SERVICE *No.* 1066 LETTER

Date: April 24, 2003 (S)

IGNITION HARNESS ROUTING INSPECTION

PA-28-181 Archer III

Figure 1
Spiral Wrap Location between Clamp and Ty Wrap on Engine Mount

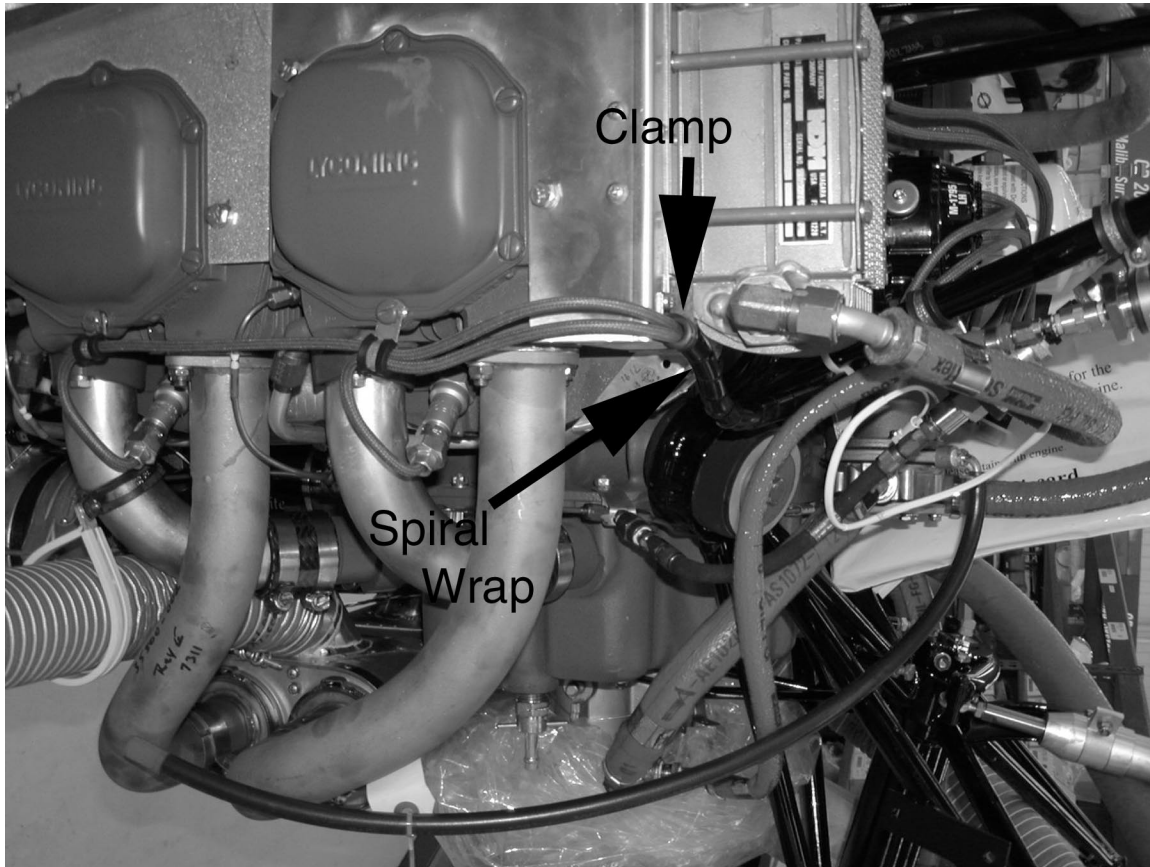
It has been discovered that the ignition cables shown in Figure 1 are sometimes improperly secured when they have been removed for maintenance. If these cables are improperly routed and secured upon re-installation, they may interfere with the oil cooler.

This letter adds a strip of spiral wrap to provide additional protection for the ignition cables if the spiral wrap is missing.

If the condition is left uncorrected it may cause damage to the ignition cables.

1. Remove upper engine cowling. Check the ignition cables and clamp indicated in Figure 1. Ensure the cables do not contact or rub against the oil cooler.
2. If the ignition cables are interfering with the oil cooler or they are not properly routed, inspect for damage, reroute and secure correctly.
3. Check for the protective spiral wrap. If the spiral wrap is missing, install an eight (8) inch strip of spiral wrap around the ignition wires from the clamp toward the magneto.

4. Install upper engine cowling.
5. Make a logbook entry indicating compliance with this Service Letter.

MATERIAL REQUIRED: One (1) each, 8 inch strip of spiral wrap, P/N 189-549 (roll), per aircraft.
